**ADDENDUM No. 1**

Date: January 27, 2015

Project Name: 3<sup>rd</sup> Street Reconstruction Phase 4 – Guadalupe St. to Nueces St.

C.I.P. No.: 8158.004

**3RD ST. RECONSTRUCTION  
 PHASE 4 - GUADALUPE ST. TO NUECES ST.  
 TRAFFIC CONTROL PLAN - RECONSTRUCTION  
 PHASE 4**

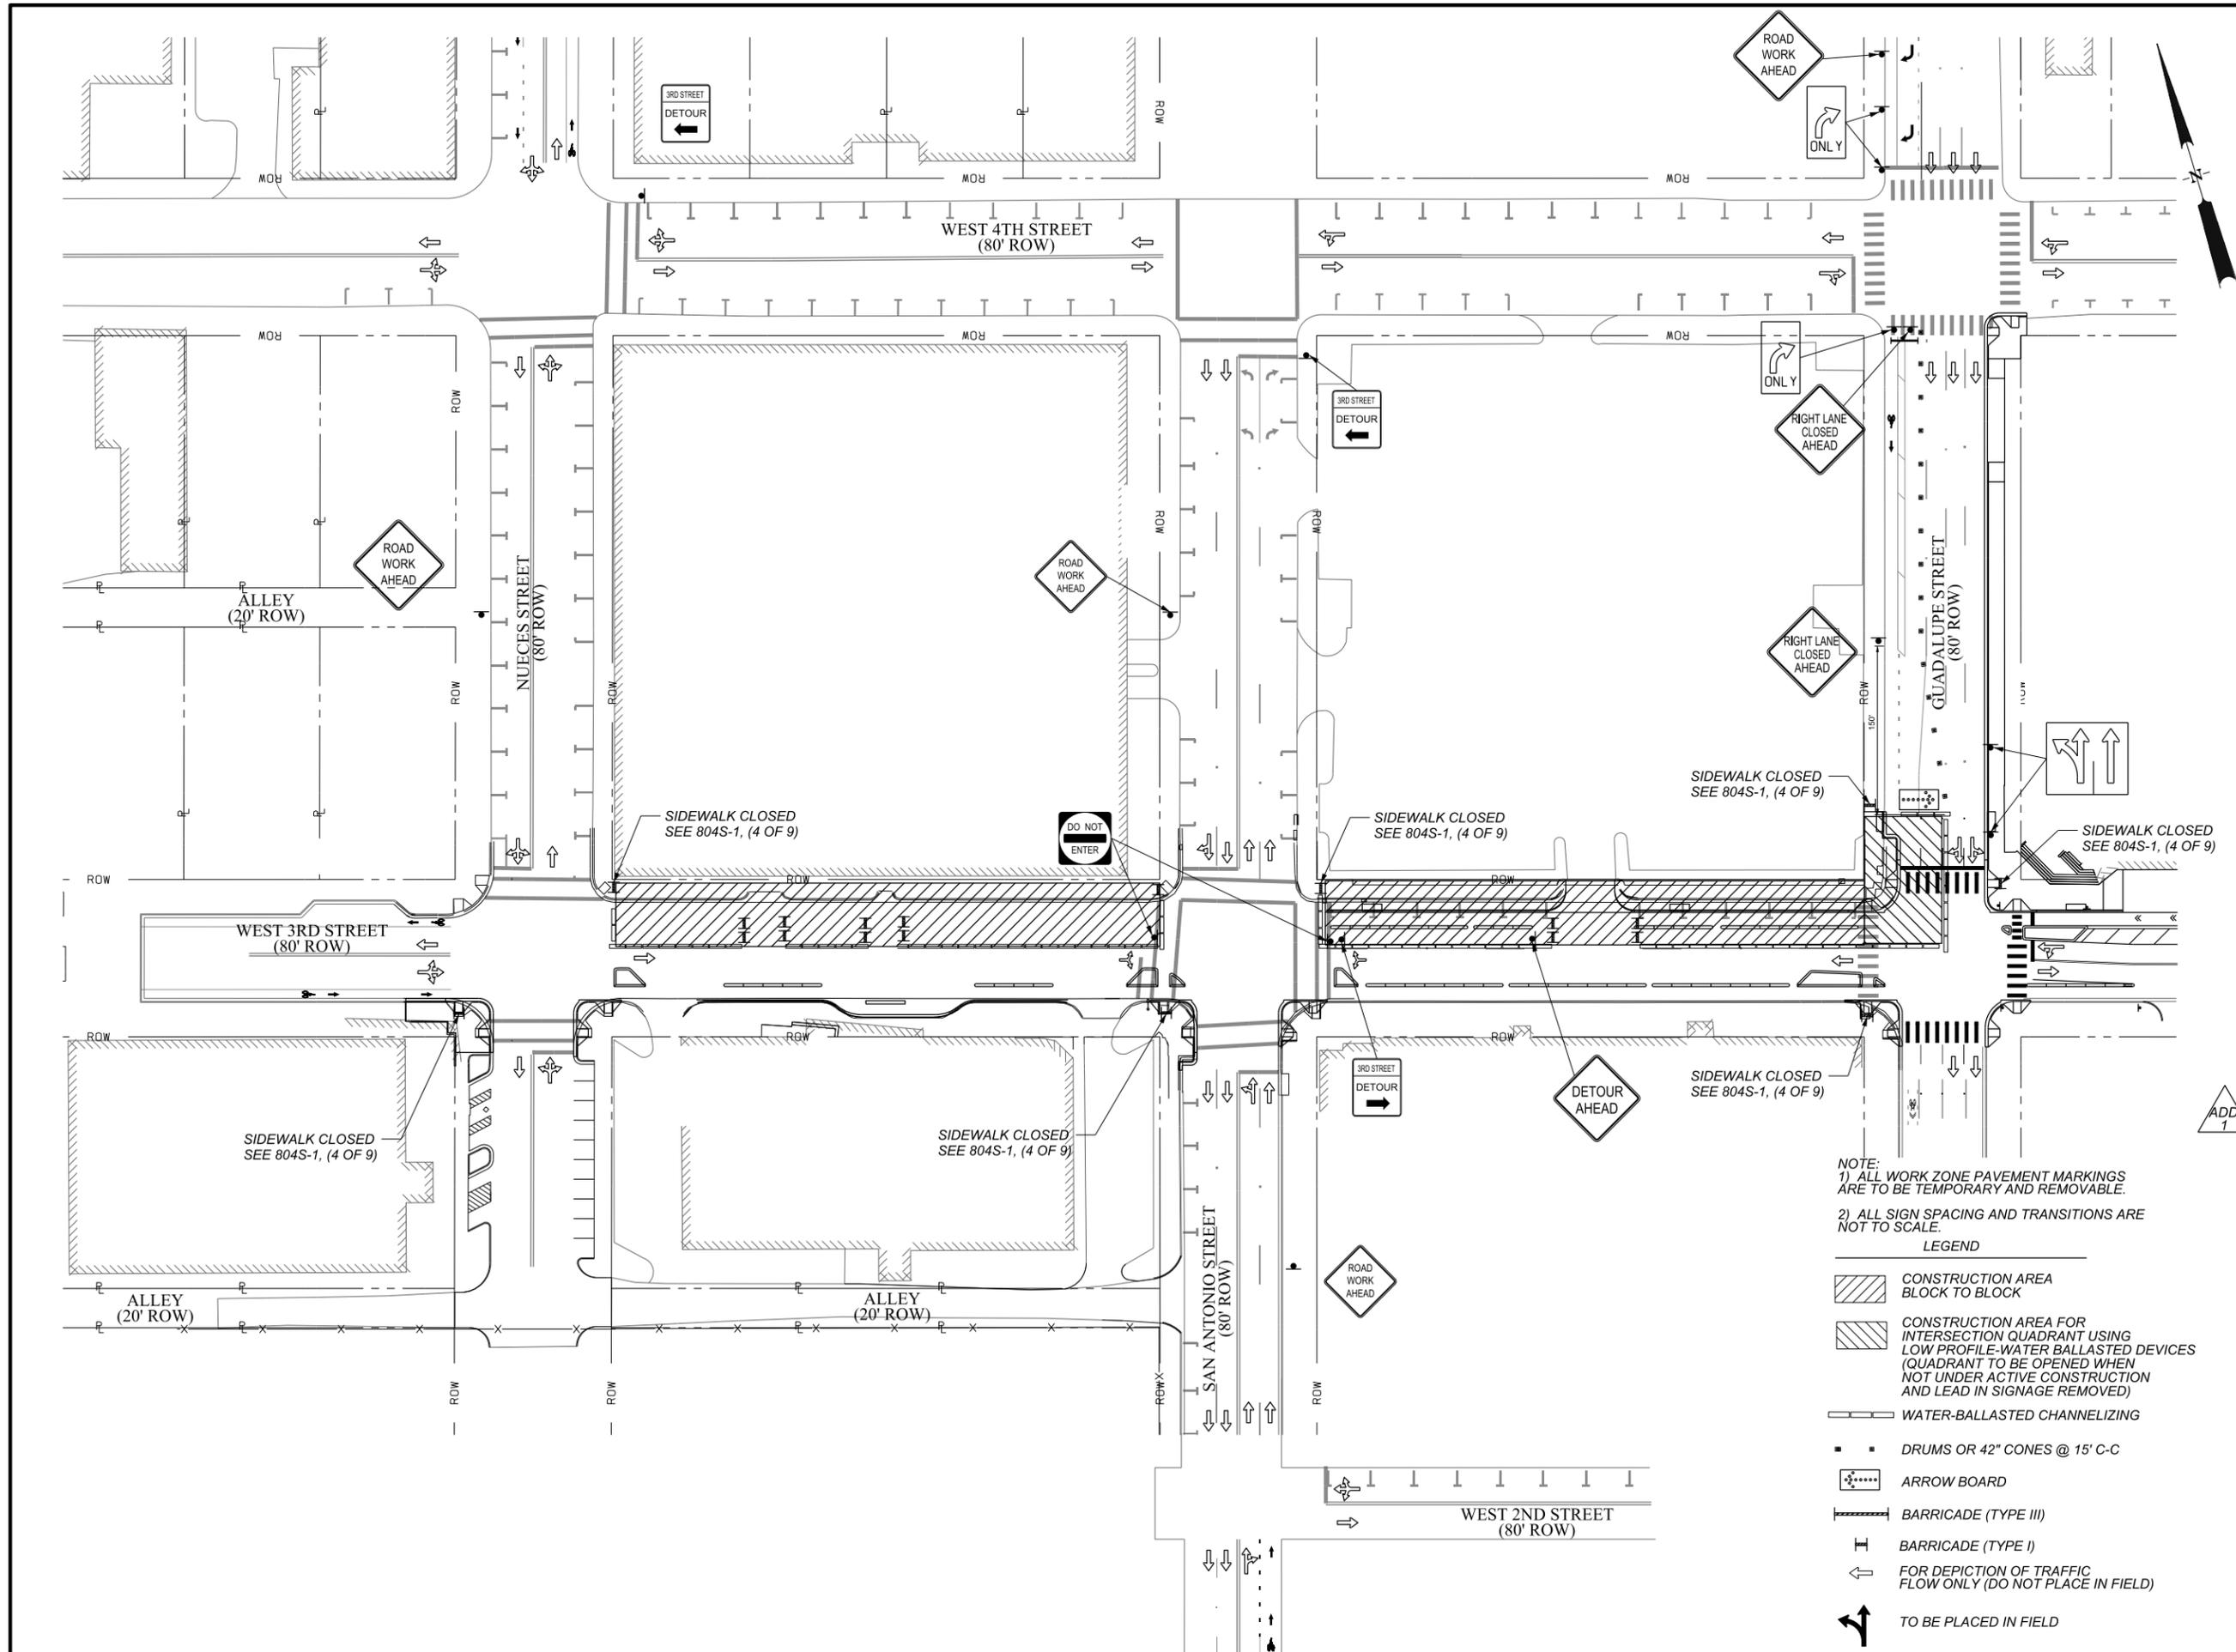
REV. NO.	DATE	REVISION DESCRIPTION
ADD FR	01/27/15	ADDENDUM 1: TITLE CHANGE

**CITY OF AUSTIN, TEXAS**  
**DEPARTMENT OF PUBLIC WORKS**  
**ENGINEERING SERVICES DIVISION**  
**3RD ST. RECONSTRUCTION**  
**PHASE 4 - GUADALUPE ST. TO NUECES ST.**  
**TRAFFIC CONTROL PLAN - RECONSTRUCTION**  
**PHASE 5**

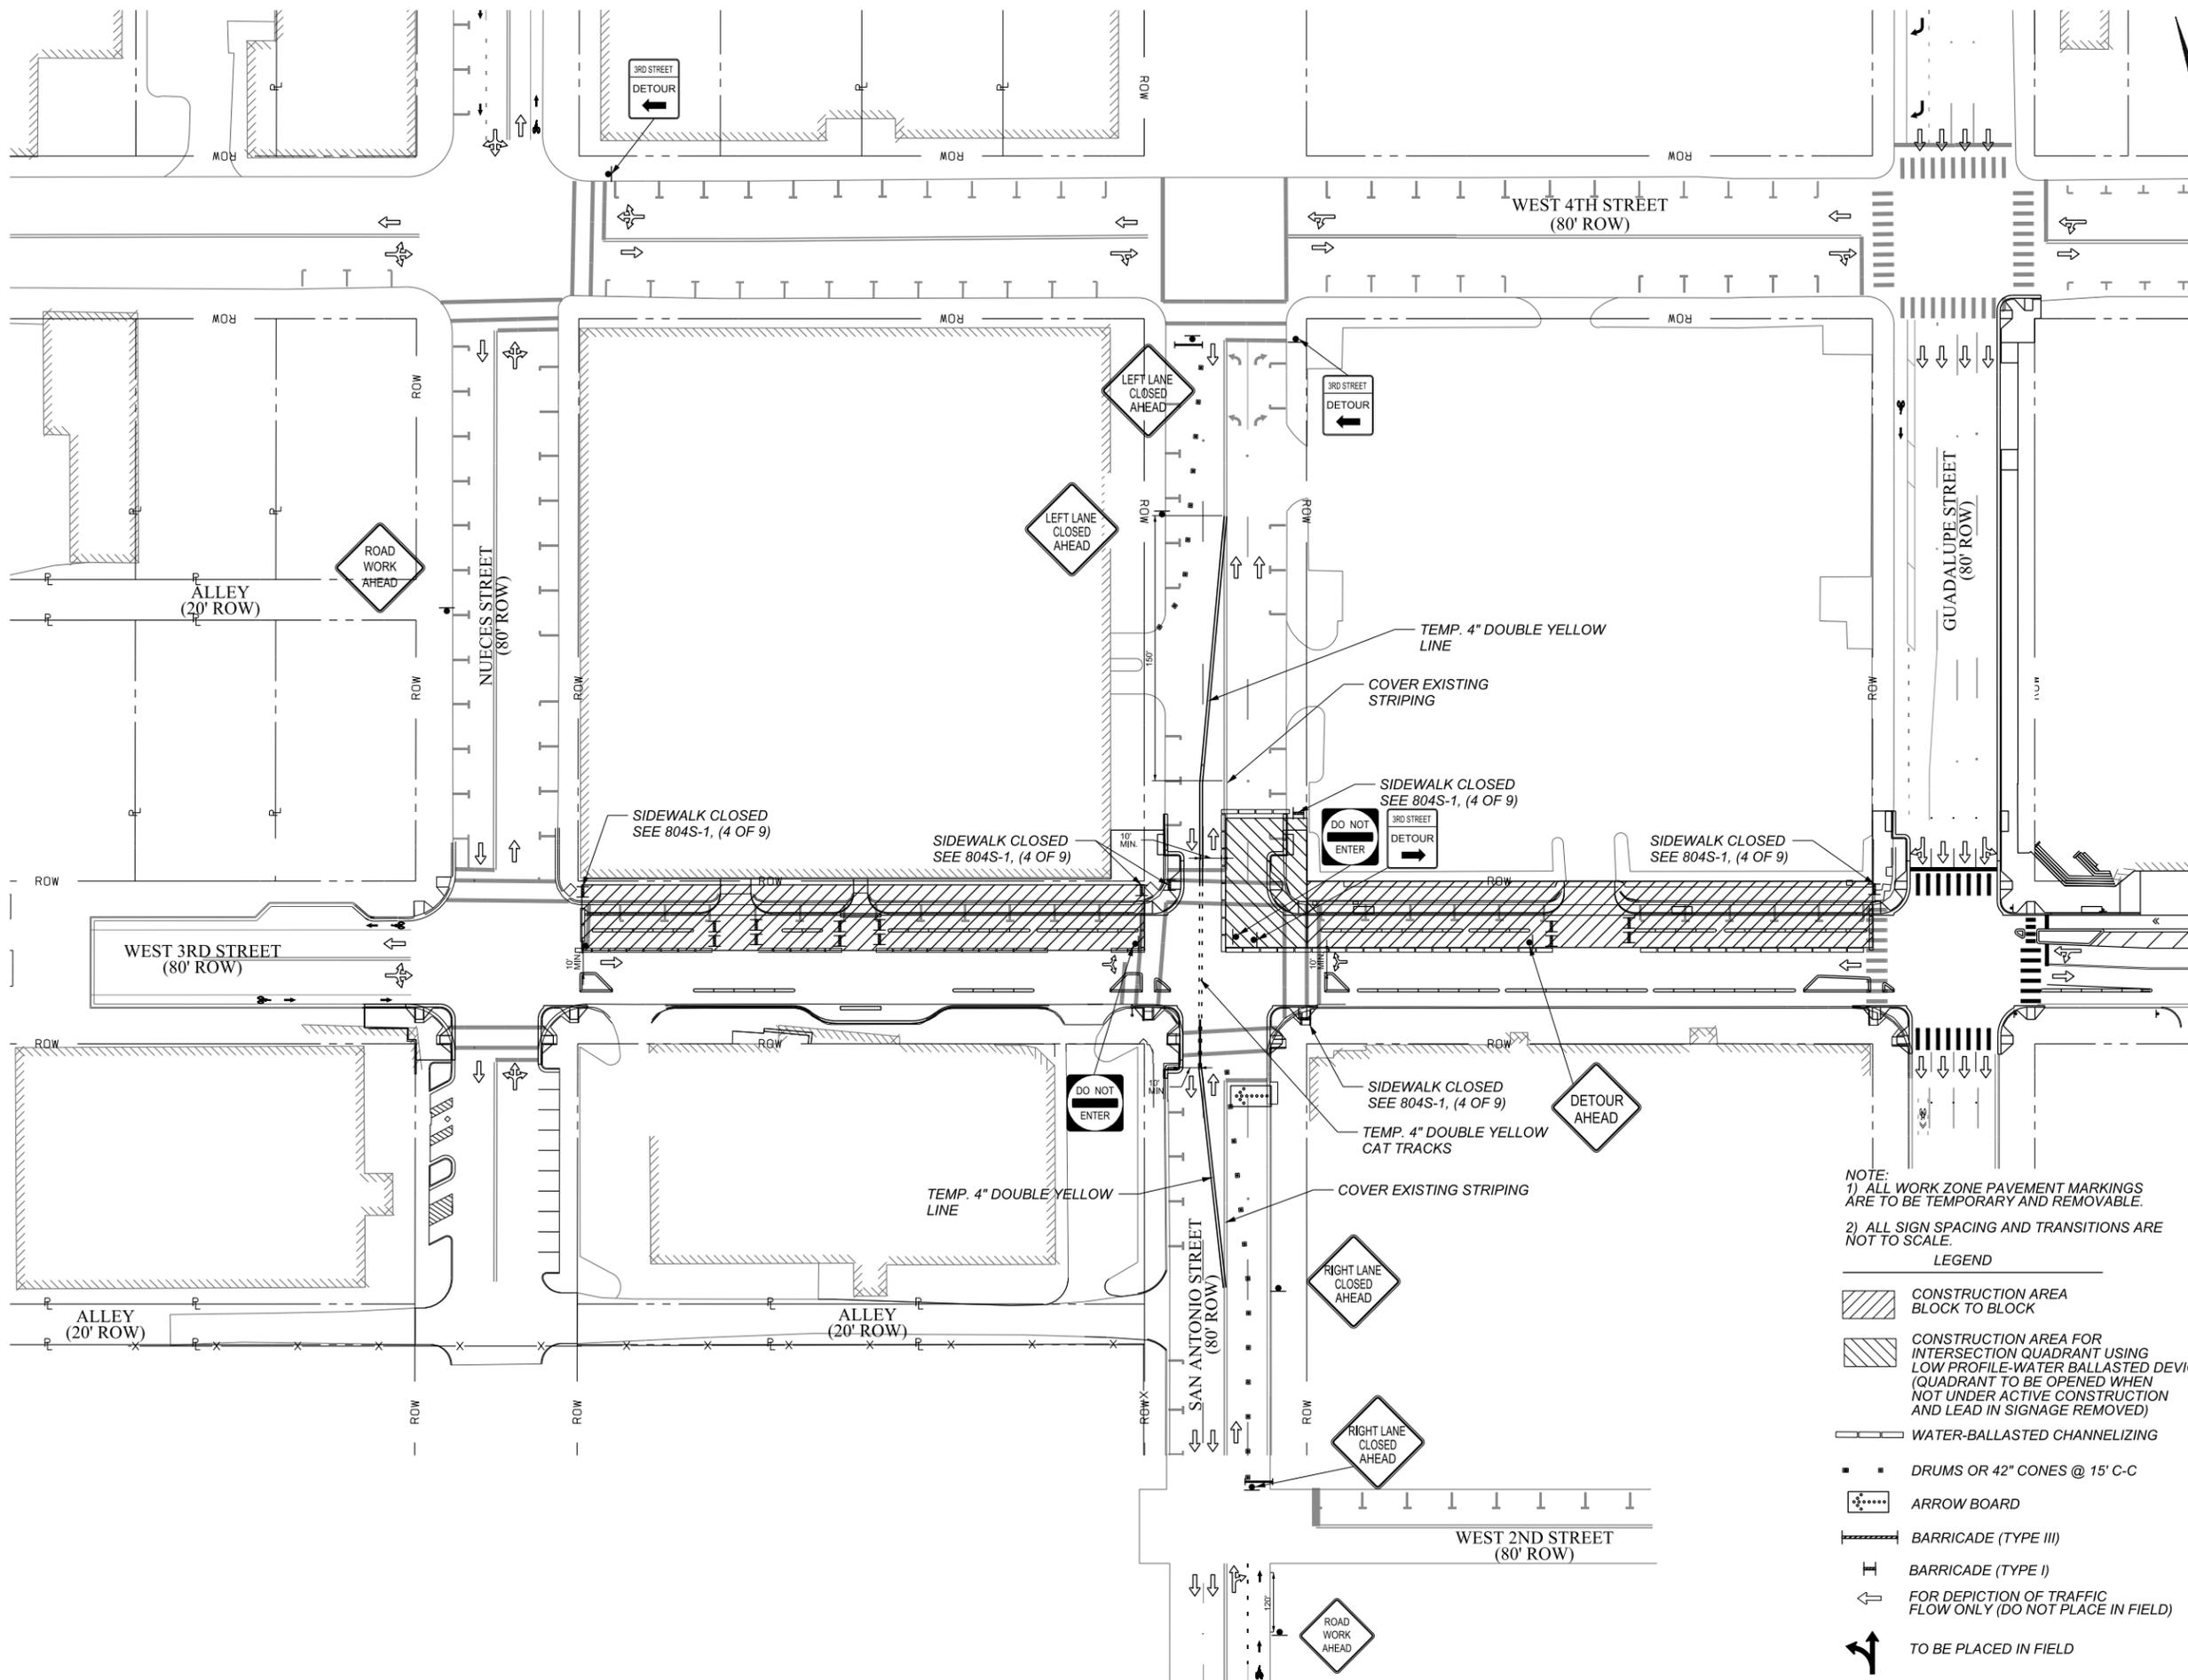
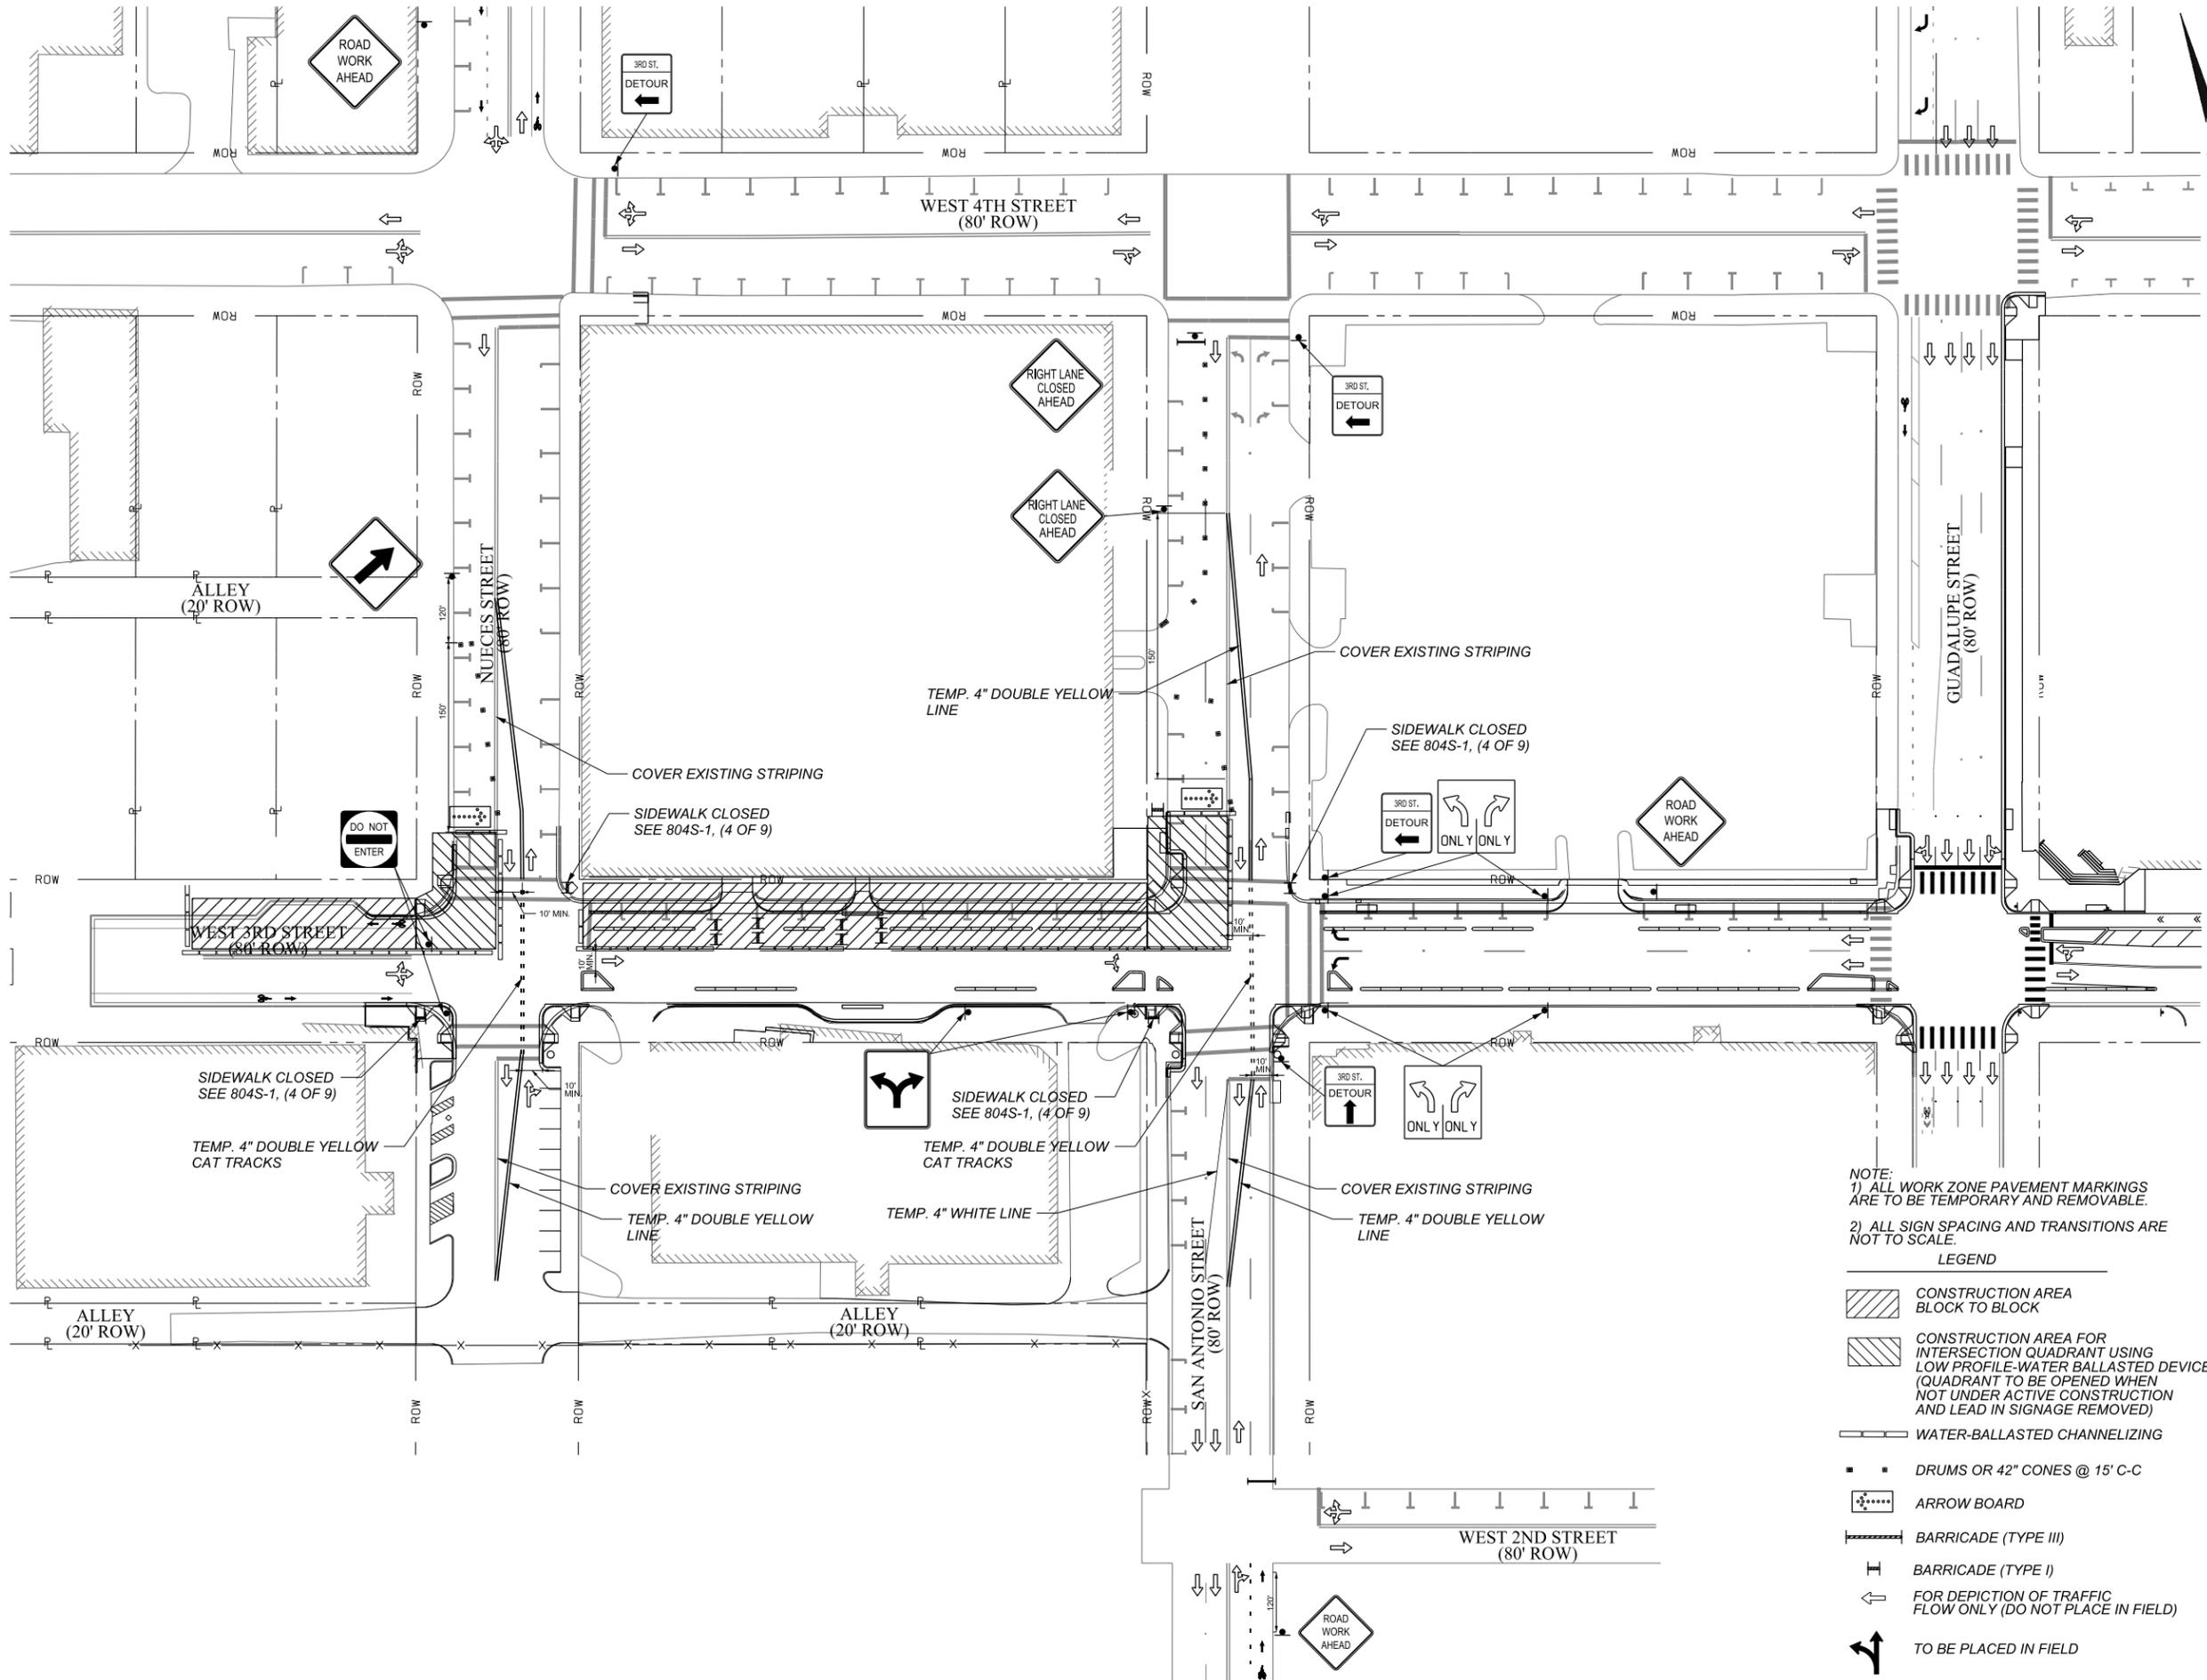
REV. NO.	DATE	REVISION DESCRIPTION
ADD FR	01/27/15	ADDENDUM 1: TITLE CHANGE
